**CITY OF LA VISTA**  
**MAYOR AND CITY COUNCIL REPORT**  
**MARCH 16, 2021 AGENDA**

<b>Subject:</b>	<b>Type:</b>	<b>Submitted By:</b>
PLANNED UNIT DEVELOPMENT SITE PLAN AMENDMENT – LOTS 1 & 16 HARRISON HILLS	RESOLUTION ◆ ORDINANCE RECEIVE/FILE	CHRISTOPHER SOLBERG DEPUTY COMMUNITY DEVELOPMENT DIRECTOR

RE: Planned Unit Development Amendment – Initial Review Letter  
Lot 1 Harrison Hills

Reference: Streck, Inc. – Harrison Hills  
Planned Unit Development Amendment Submittal Comments  
Project No.: 0118087.06-003

1  
E0.01  
Electrical Site Plan

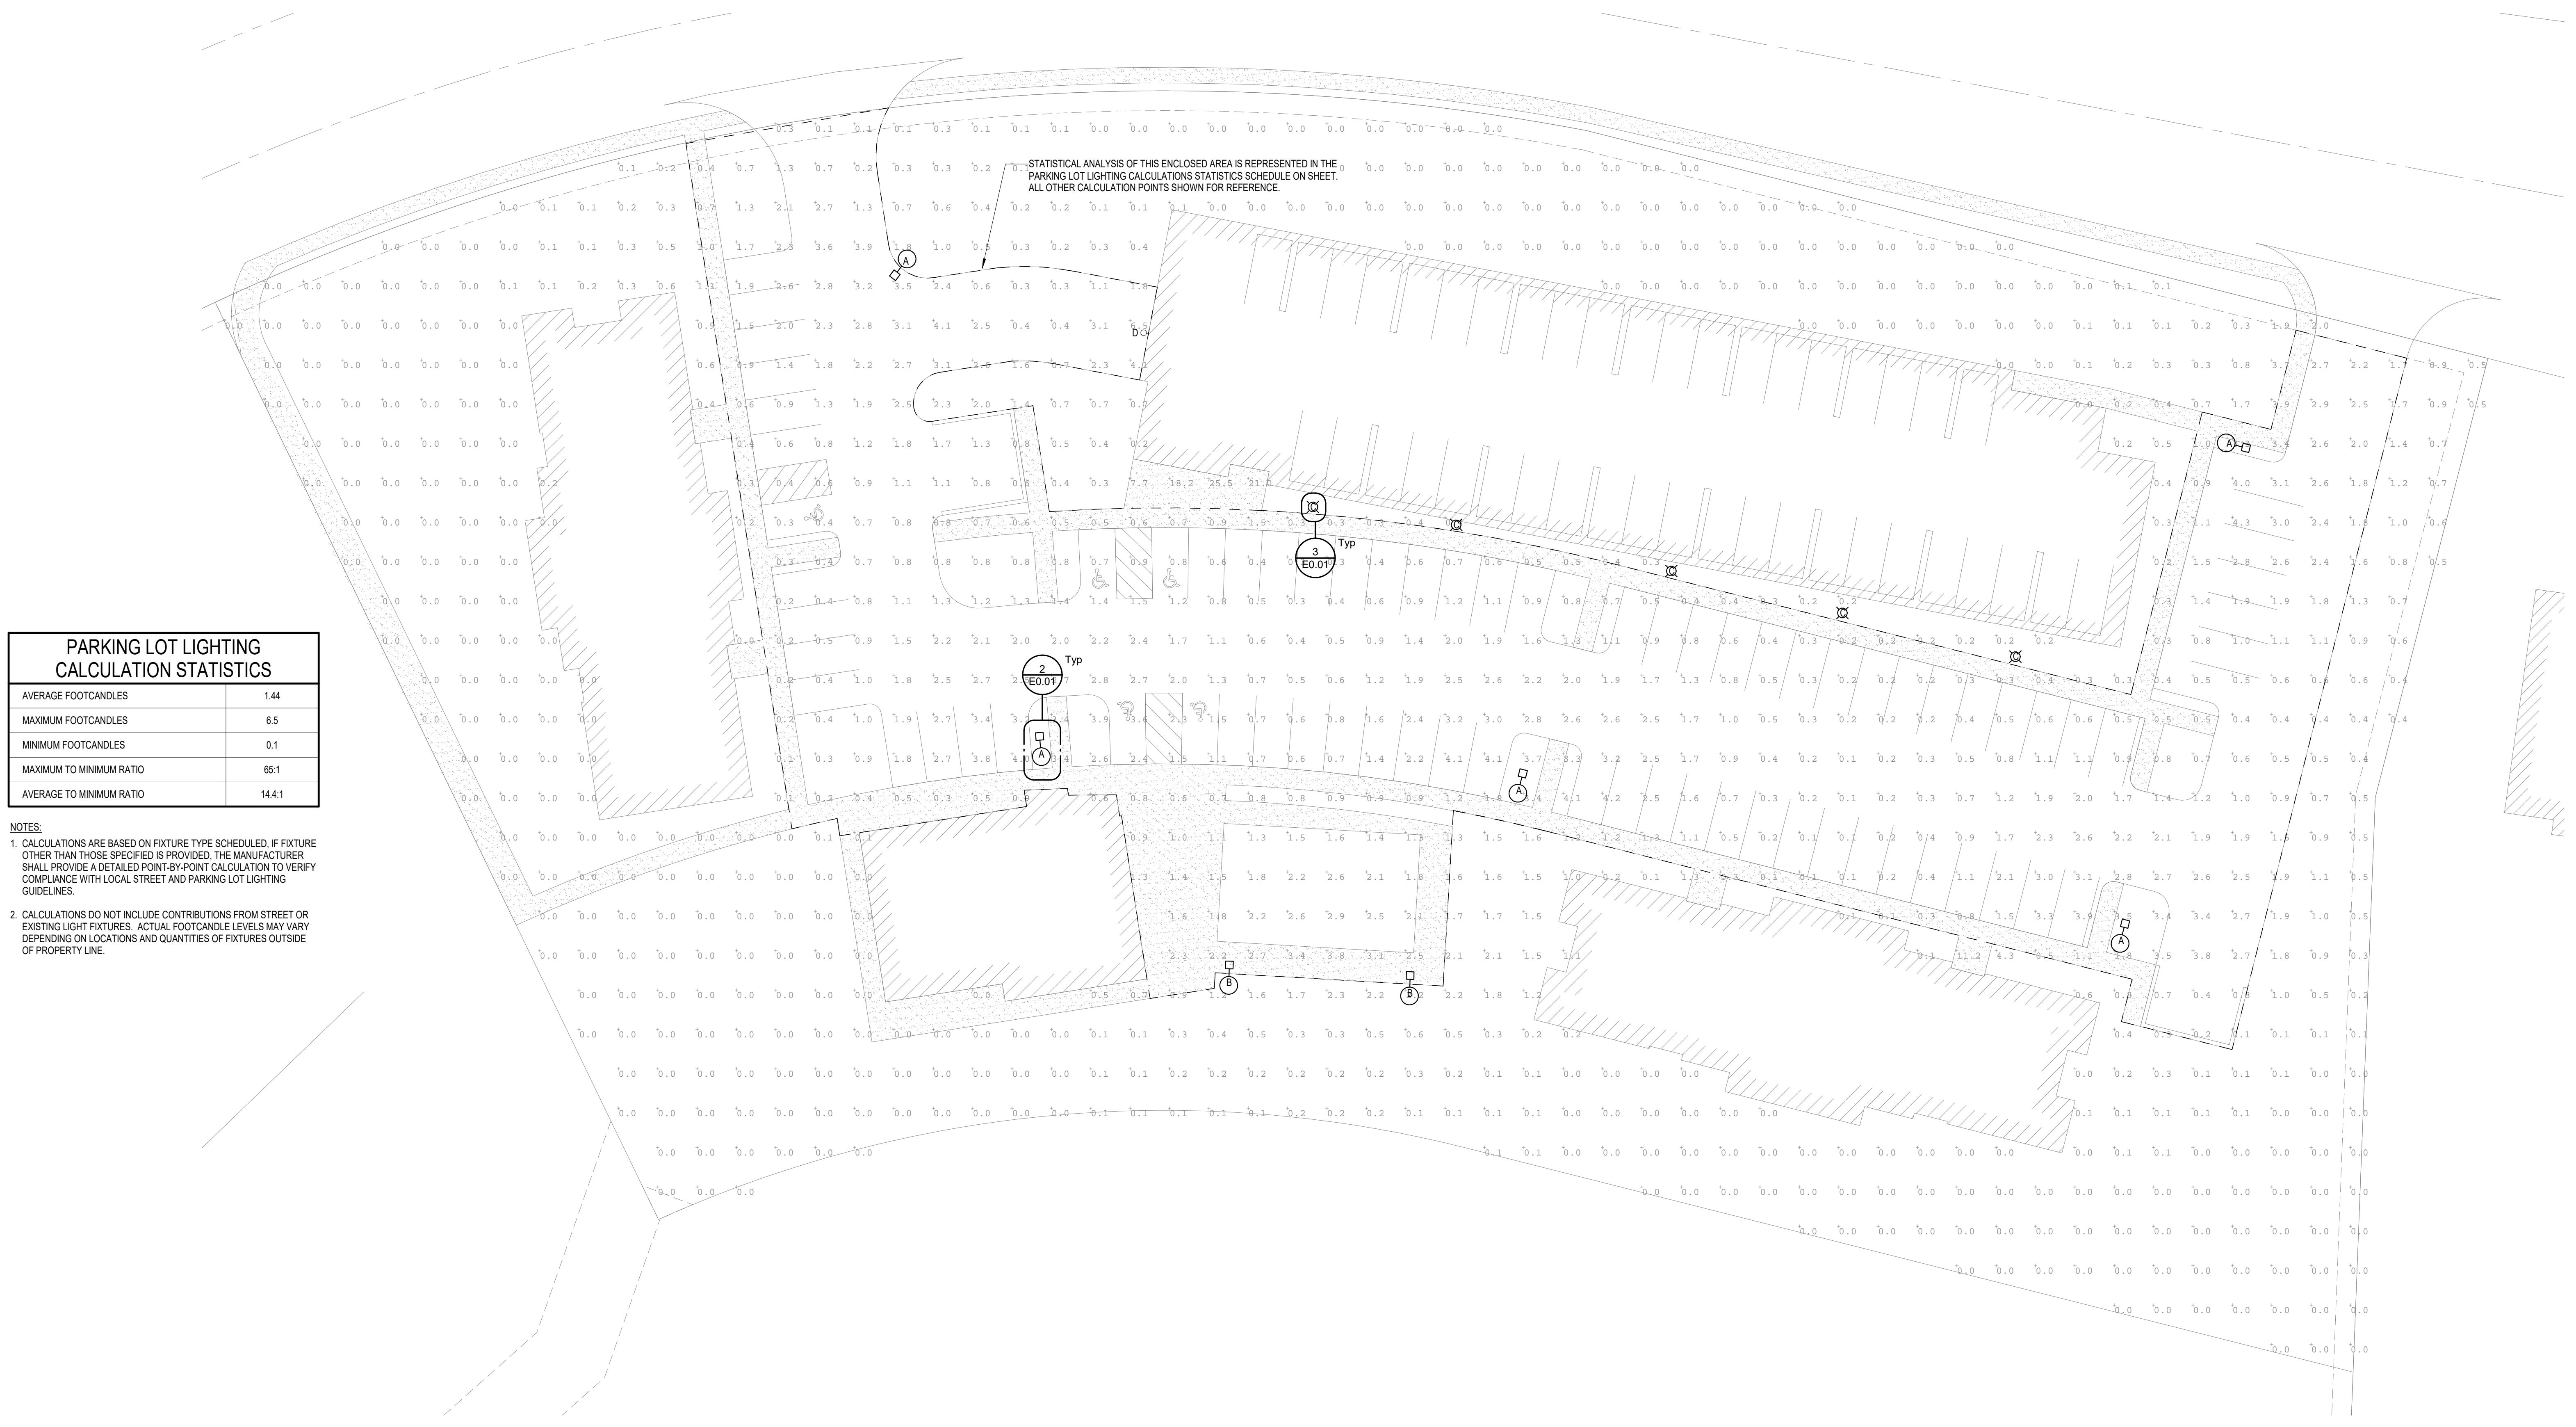
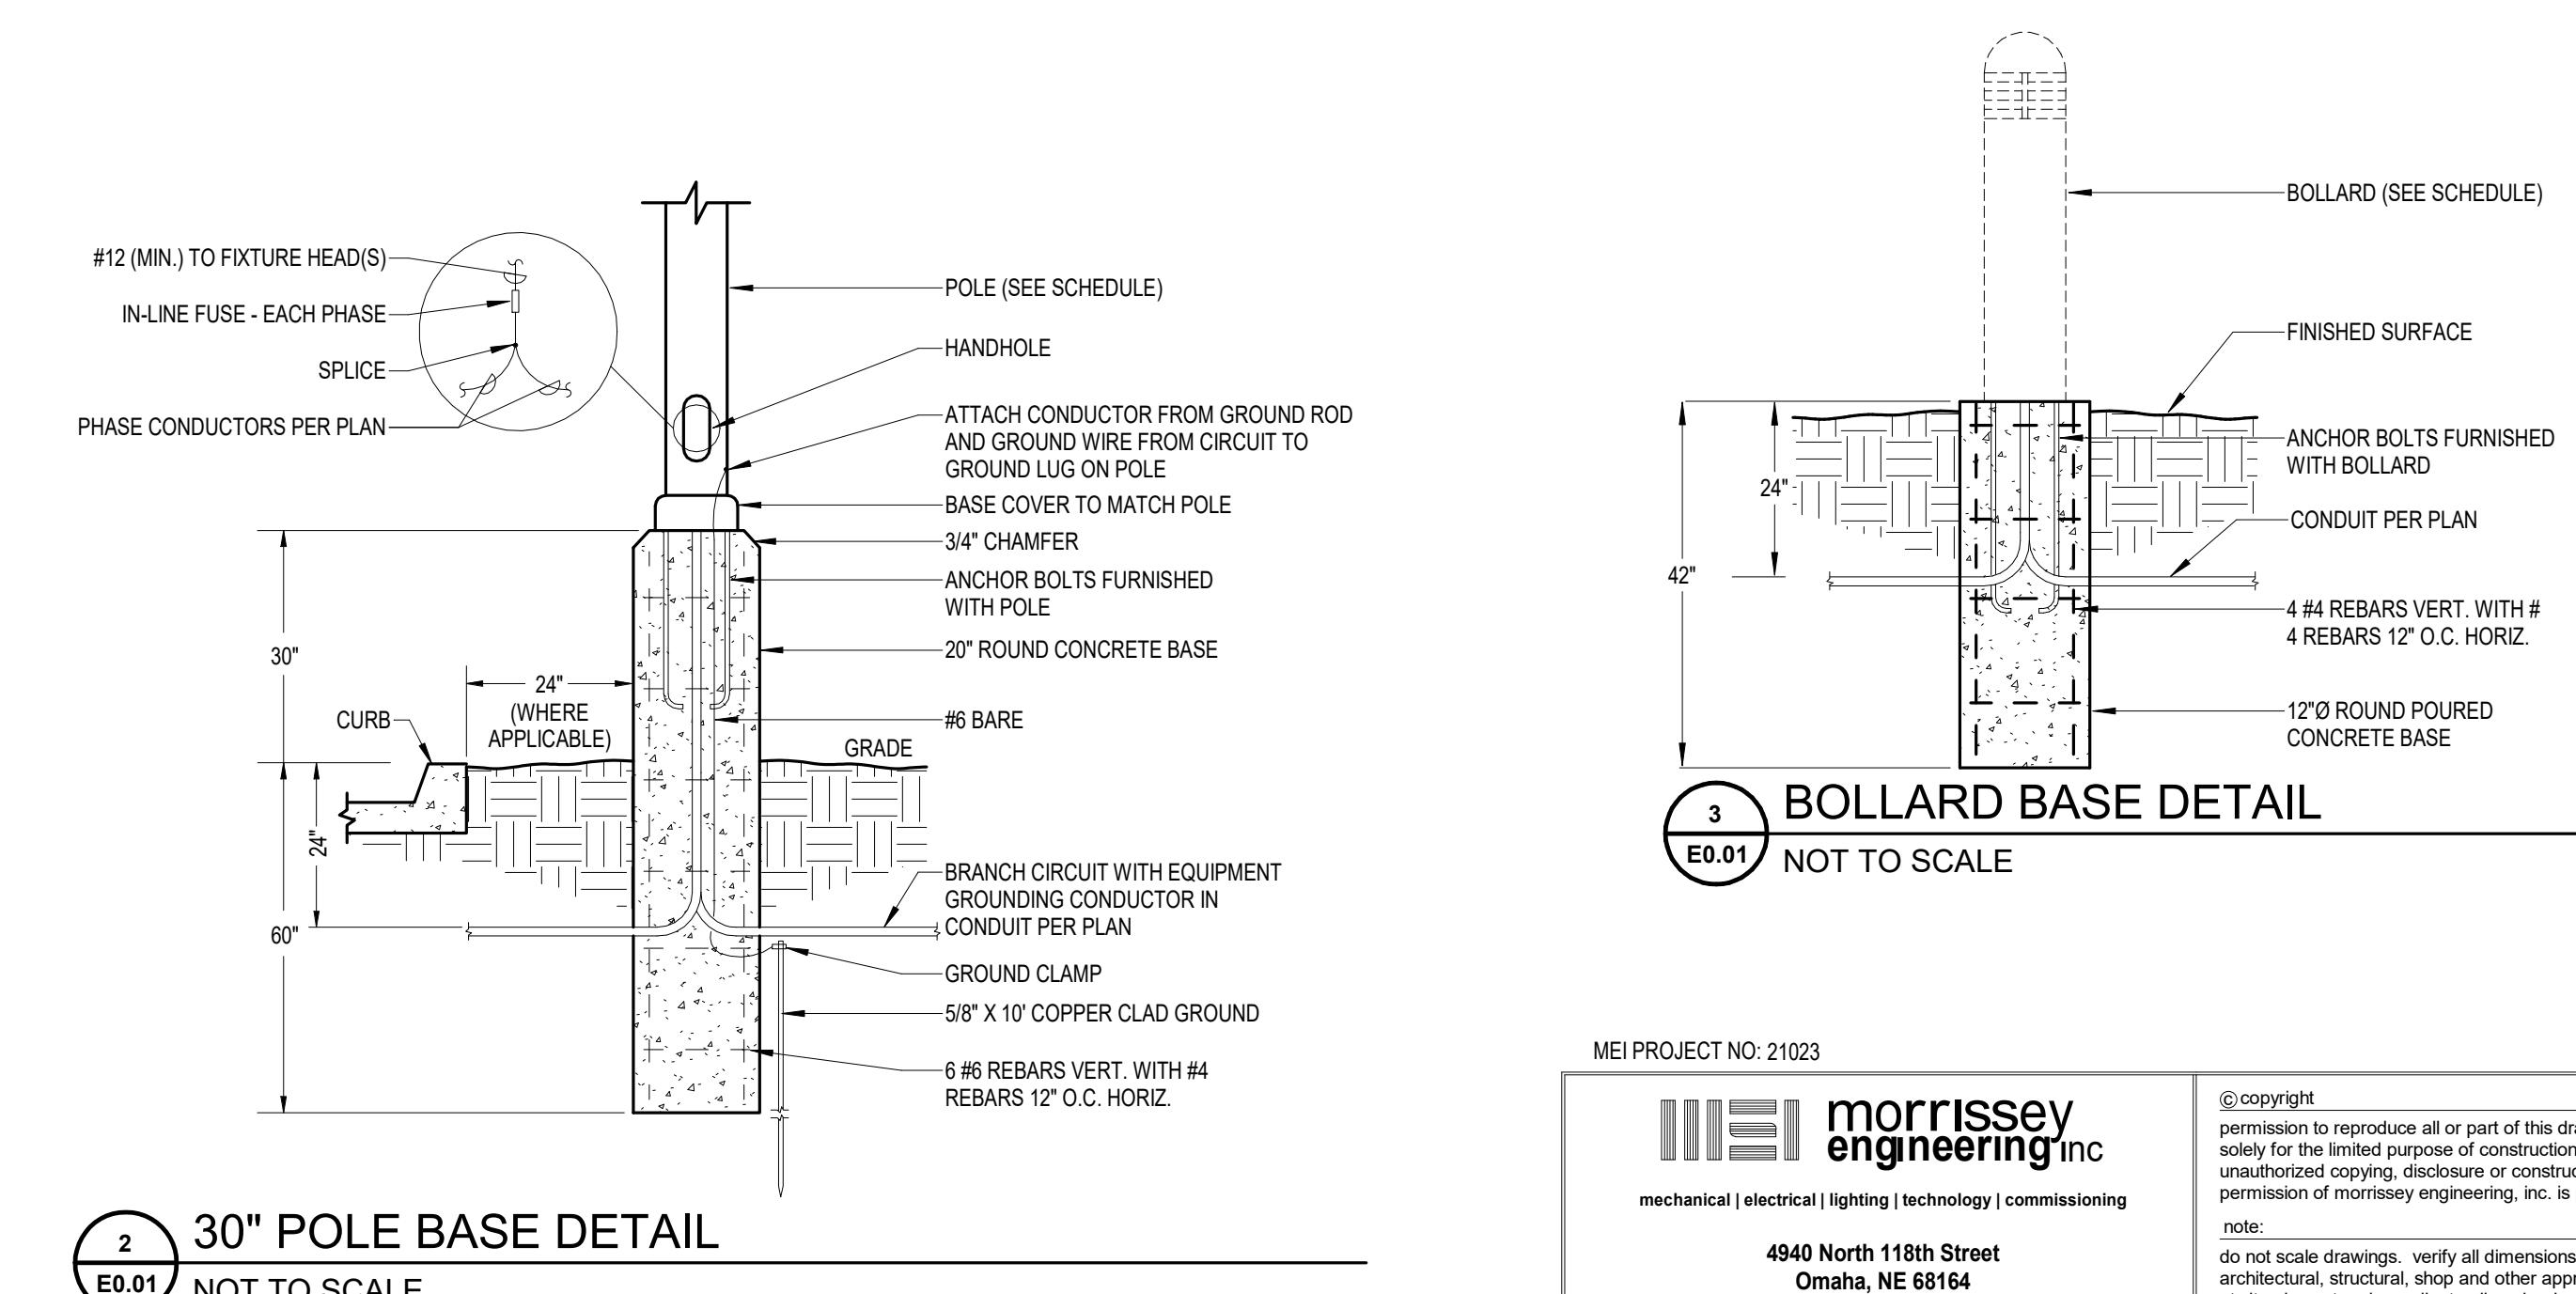
13. Section 5.15.04.21 – Exterior lighting needs to be shown as to ensure there are no adverse impacts to the adjacent multi-family residential units. Please submit a detailed photometric plan to support this requirement.

No pole-based site lighting has been depicted in the PUD plan set. Any pole-based lighting needs to abide by the Gateway Corridor District Design Guidelines. See the Guideline for the parking lot light fixture and pole required for developments within the Gateway Corridor District.

**Response:** A site photometric plan has been provided as requested. All pole-based lighting will abide by the Gateway Corridor District Design Guidelines.
